UNITED STATES OF AMERICA
NUCLEAR REGULATORY COMMISSION
ATOMIC SAFETY AND LICENSING BOARD

(Diablo Canyon Power Plant Independent
Spent Fuel Storage Installation)

MEMORANDUM

**Evaluation of the
San Luis Obispo County
Emergency Response Plan**

FIGURE 3
Protective Action Zones

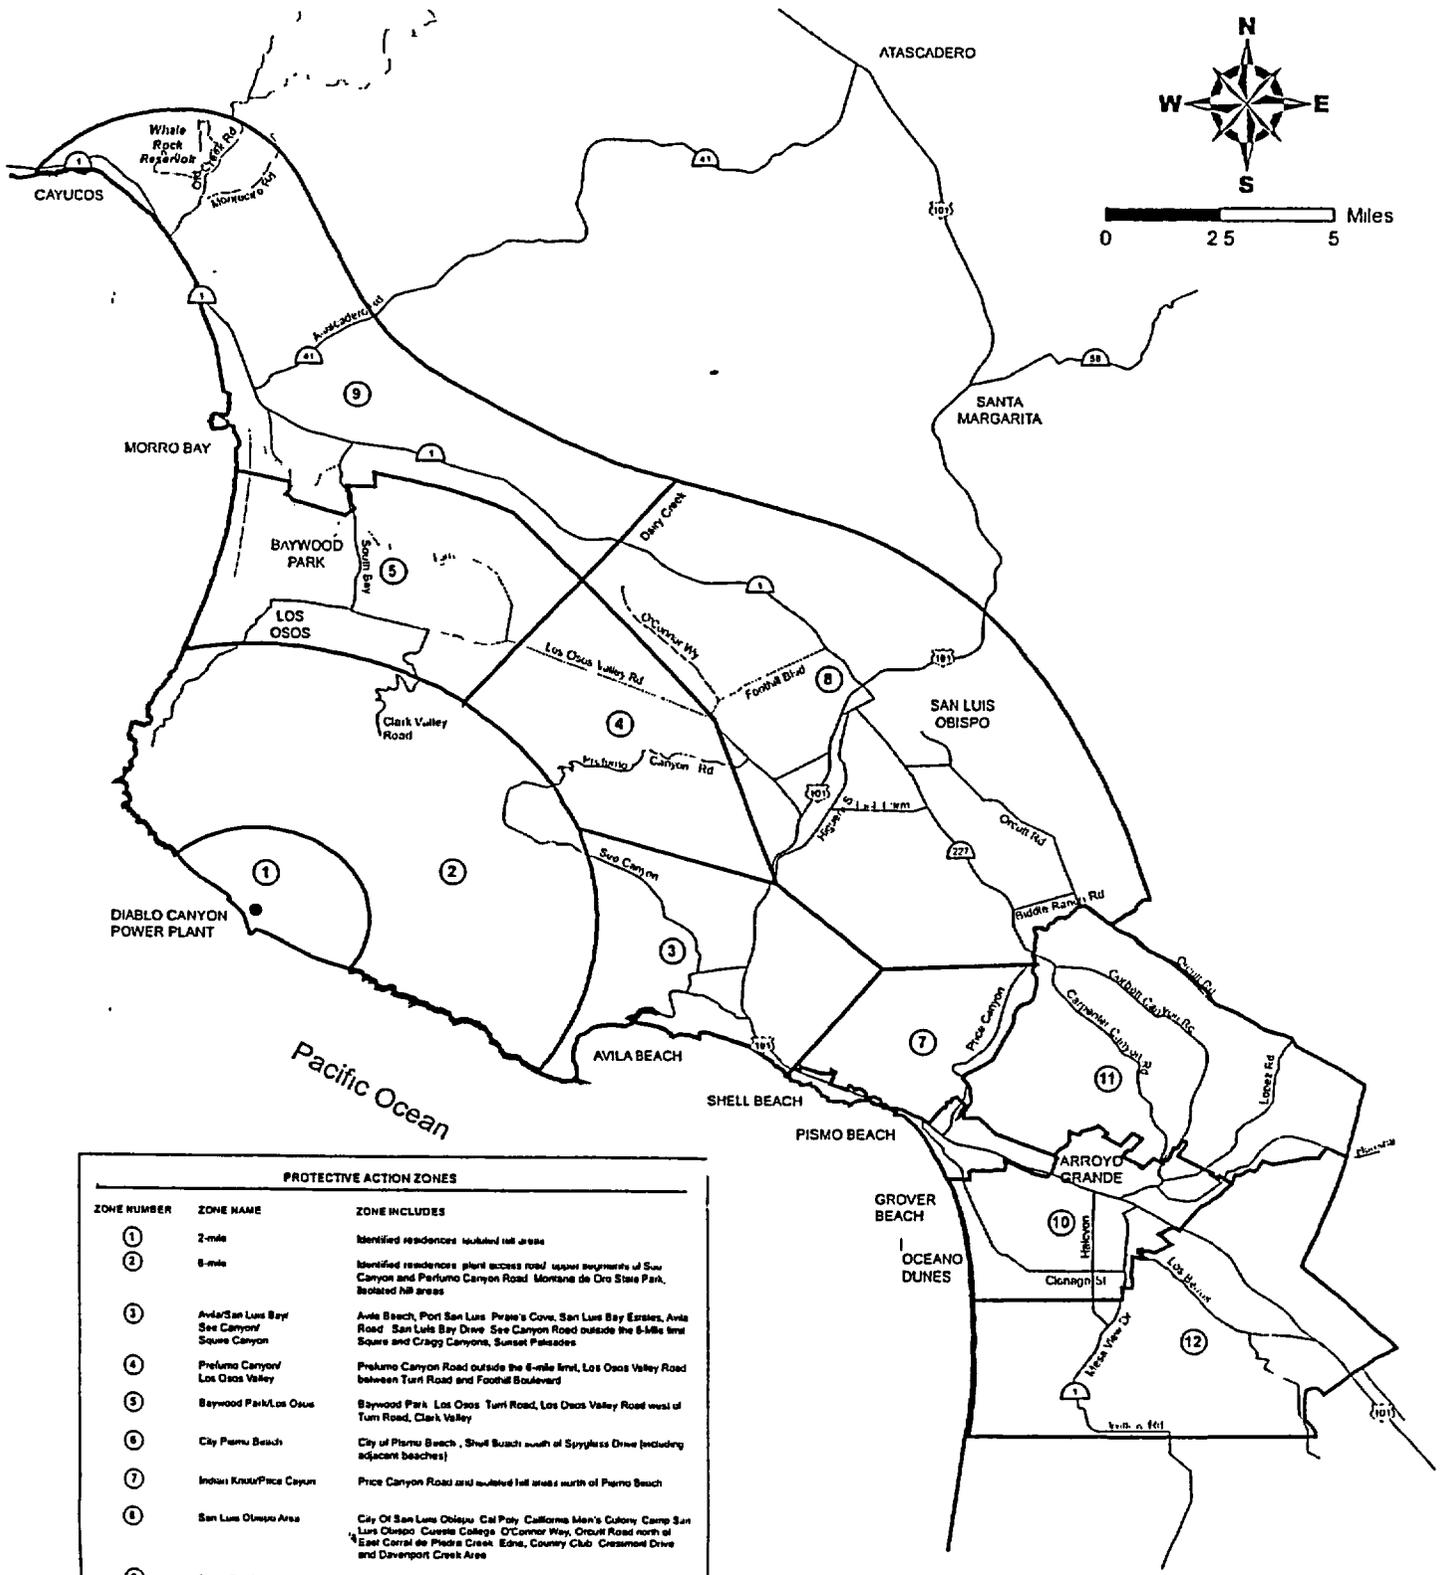
1. The County Office of Emergency Services should consider revisions to the Protective Action Zone boundaries within the Emergency Response Plan. It is recommended that the Port San Luis/Avila Valley area be moved from Protective Action Zone 3 to Protective Action Zone 2. This proposed PAZ boundary revision would result in improved communications with and involvement by the Port San Luis Harbor District and the CDF/County Fire Station in Avila Beach by being informed at earlier stages of an emergency event. The Port would also be notified of an Unusual Event if it were located within PAZ 2. Although PAZs 1 and 2 lie within a six-mile circular radius of the Diablo Canyon Nuclear Power Plant, Federal Criteria (the third document analyzed in this analysis) states that the actual shape of an emergency planning zone should be based upon the particular characteristics of a site. There are several unique aspects associated with the Port San Luis/Avila Valley area which justify this recommended PAZ boundary revision:

- a) Port San Luis and Avila Valley are situated in close enough proximity (just beyond the six-mile radius which defines the boundary to PAZ 2) to the Diablo Canyon Nuclear Power Plant to be significantly impacted by any radiological release or emergency event at the facility.

- b) Based upon meteorological data, the prevailing wind direction (over 50% of the time) would disperse any radiological release from the Diablo Canyon Nuclear Power Plant either directly to or near the Port.

- c) A radiological release from the Diablo Canyon Nuclear Power Plant could reach the Port San Luis/Avila beach area within an extremely short time frame, as little as 27 to 37 minutes, depending on wind speed and direction.

FIGURE 5
Avila Beach Local Evacuation Routes

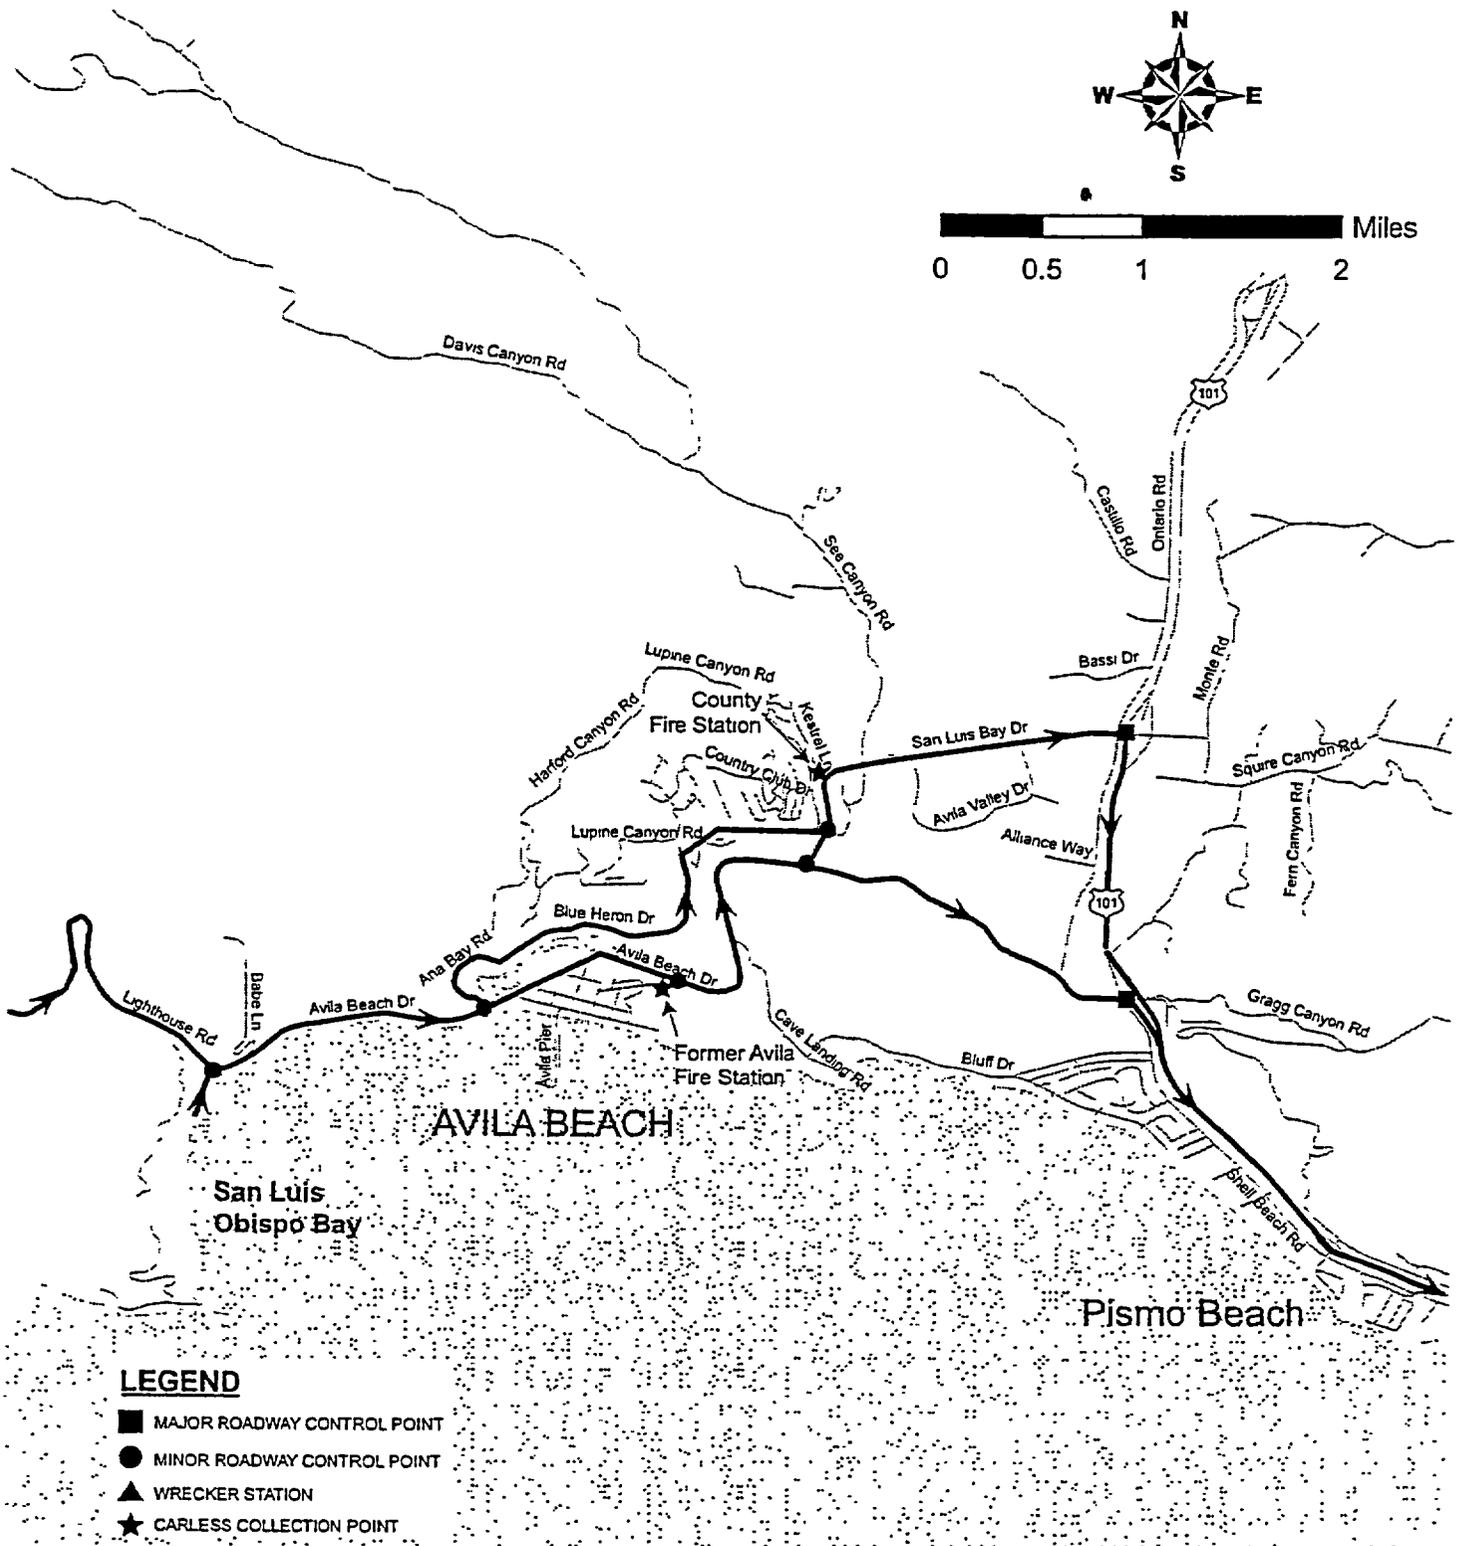
5. The various evacuation scenarios within the Evacuation Time Assessment are limited in their scope in that they assume that the primary evacuation routes, those being Avila Beach Drive and San Luis Bay Drive, are fully operational. This assumption is based upon the hope that all departures occur without accident (see Recommendation #3 above), that all emergency workers are present and that the emergency (which could be initiated by an earthquake or attack) does not remove a bridge or other critical roadway link (due to flood or landslide). The Evacuation Time Assessment should address such scenarios with particular attention to the provision of alternative routes of egress from the otherwise land-locked Port San Luis/ Avila Valley area (see Recommendation #7 below).

Based upon the experience of the Port San Luis Harbor District and residents of the area (particularly on holidays or during special events), such bottlenecks are highly likely to occur during an emergency event at the Diablo Canyon Nuclear Power Plant. According to Federal criteria, the Evaluation Time Assessment should contain specific recommendations for actions that would be taken to significantly improve evacuation times. Specific improvements to the roadway network in the area may include but are not limited to:

- a. Extension of Cave Landing Road past its current terminus at Pirate's Cove to ultimately connect to Highway 101 in Shell Beach. This roadway extension could be an emergency-only, all-weather paved roadway which would provide an alternate means of vehicular access for those departing Port San Luis and Avila Beach. Such traffic would not compete for roadway capacity with residents of the San Luis Bay Estates, Bassi Ranch and other residential areas closer to Highway 101.
- b. Provision of an emergency-only access roadway for workers from the Diablo Canyon Nuclear Power Plant through Montana del Oro State Park. This access alternative would remove approximately 900 vehicles from the existing primary access routes.
